1970 Corvette: Service Bulletin: Water Pump Bearing and/or Shaft Failures

Bulletin No: 71-T-37

Date: June 23, 1971

FIGURE-1

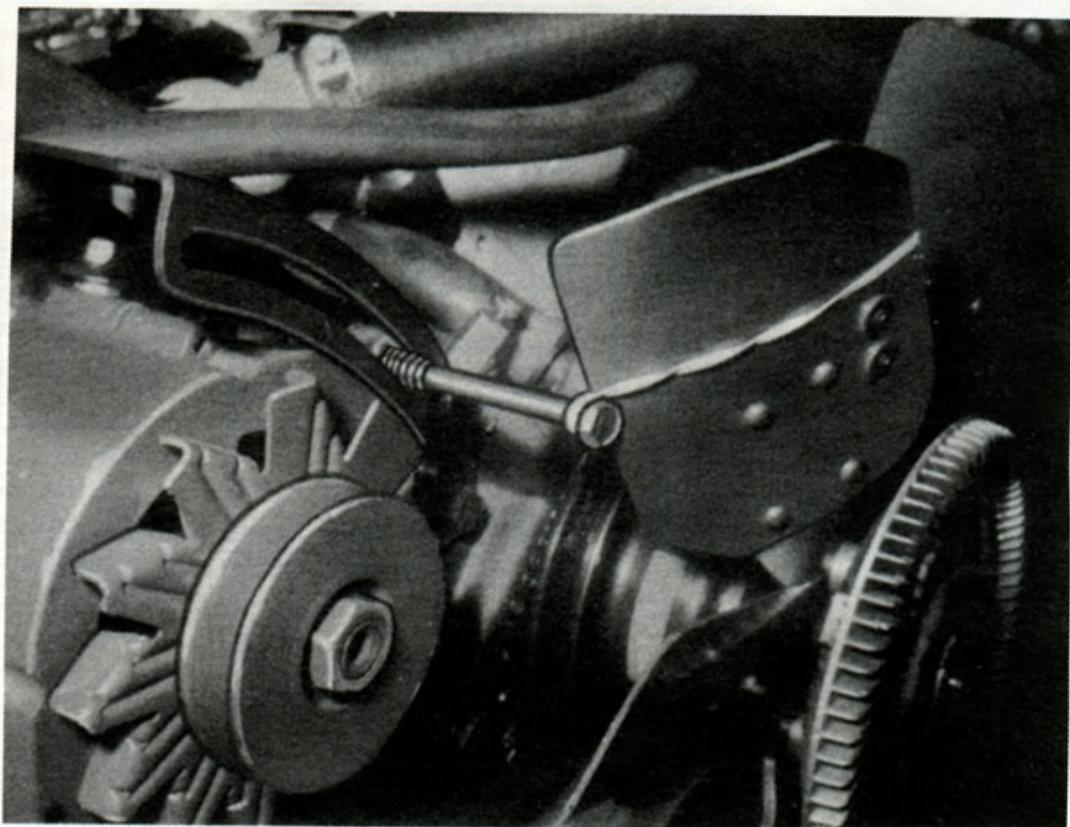
- A. Secure the fan blade to prevent rotation. (See Figure 1).
- B. Mount a dial indicator (.001 graduations) to the engine and place the indicator pointer on the fan blade spider. Preferably on the longest

FIGURE-2

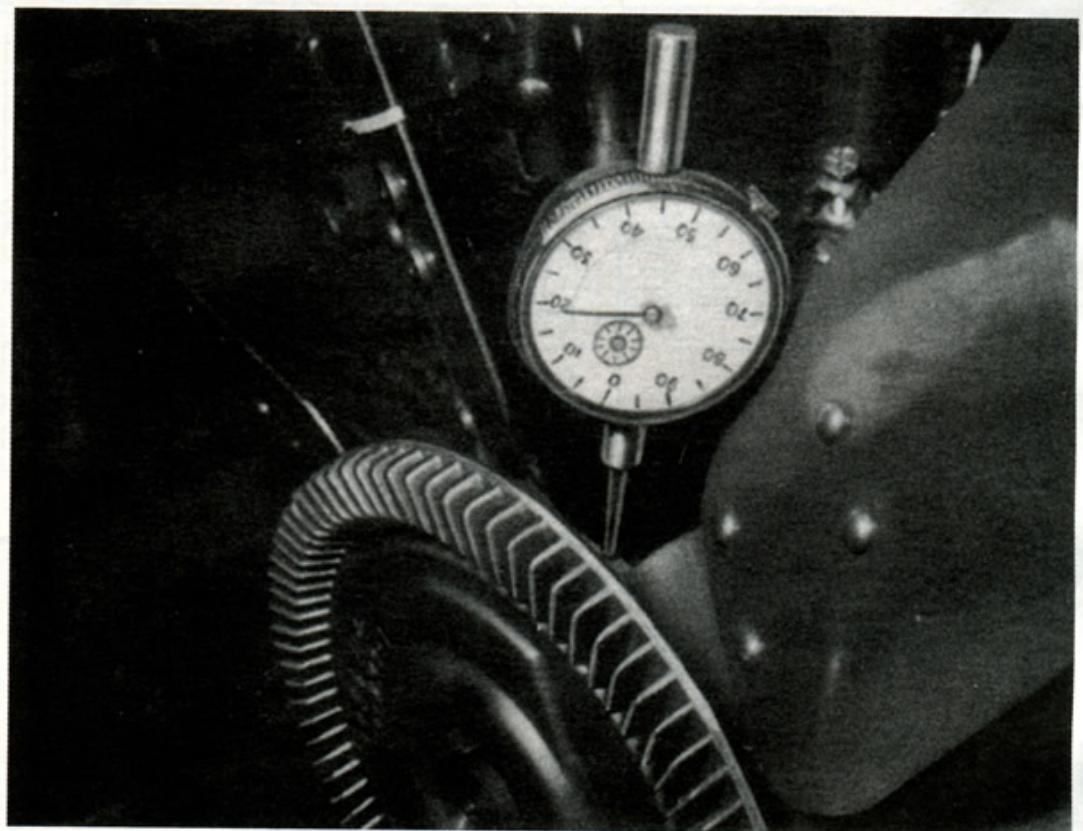
band or space on the spider. (See Figure 2).

FIGURE-3-STANDARD SHIM STOCK

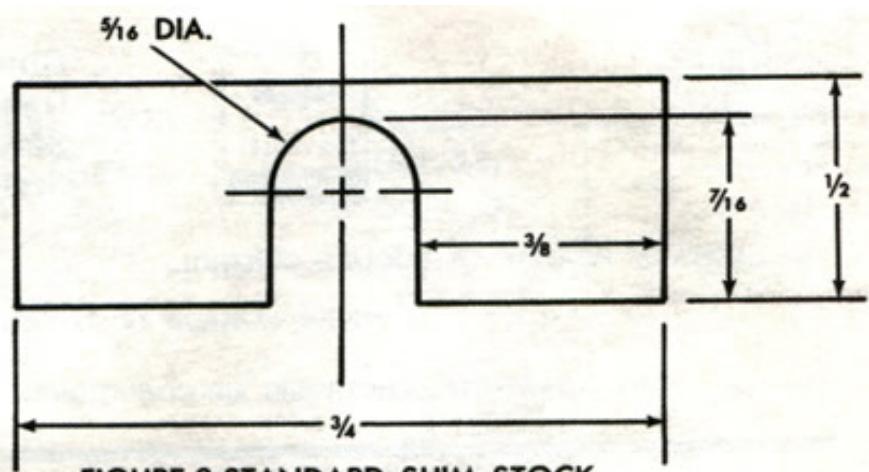
- C. Rotate the water pump pulley in one direction and note the total amount of indicator needle movement. This represents the total radial run-out. Mark the point on the pulley at which the highest reading is obtained.
- D. If the total indicator reading is less than .006 inch, the assembly is within specification. Install fan belt and adjust. If the total indicator run-out exceeds .006 inch, proceed to Step "E".
- E. Divide the total indicator reading in half and obtain this thickness from shim stock (1/2 x 3/4) and rework per Figure 3. Place this shim pack between the water pump pulley and fan clutch hub at the bolt closest to the point marked on the pulley in Step "C". If the mark on the pulley is between two bolts so that it is difficult to determine which bolt is closest, place two shim packs; one under each bolt on either side of the mark. (See Figure 4).

FIGURE-4

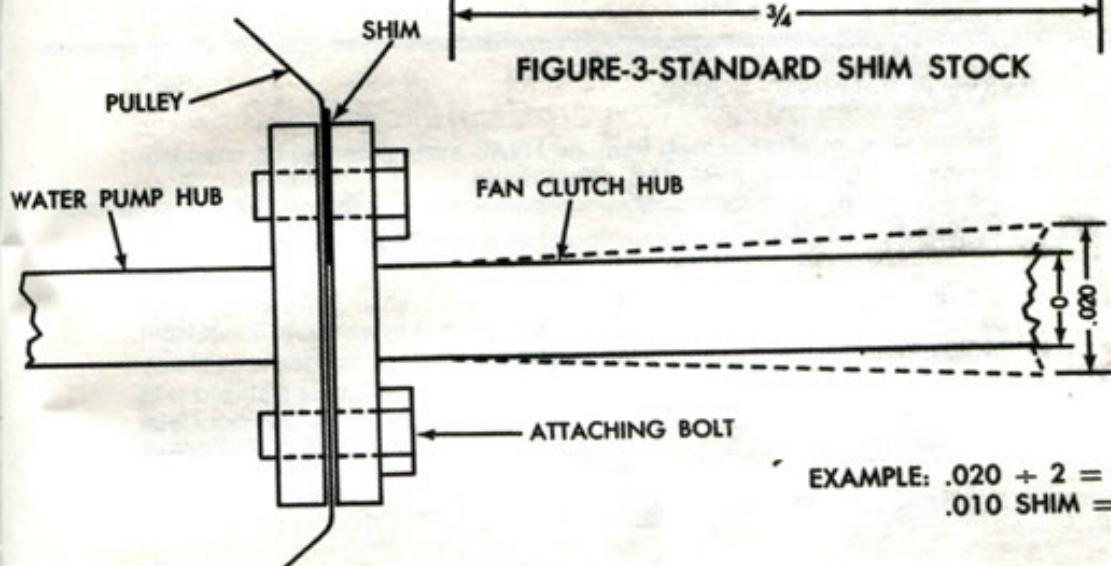
TOTAL RUN-OUT \div 2 = SHIM THICKNESS
TO OBTAIN ZERO (-0-) RUN-OUT

- a. When one shim pack is used, first, torque the bolt over which the shim pack has been placed; second, the bolt opposite the first; and finally, the other two. Recommended torque is 25 lbs. ft.
- b. When two shim packs are used, each bolt must be torqued partially; then to full torque alternating between opposite bolts; then the other two bolts in the same manner. Recommended torque is 25 lbs. ft.
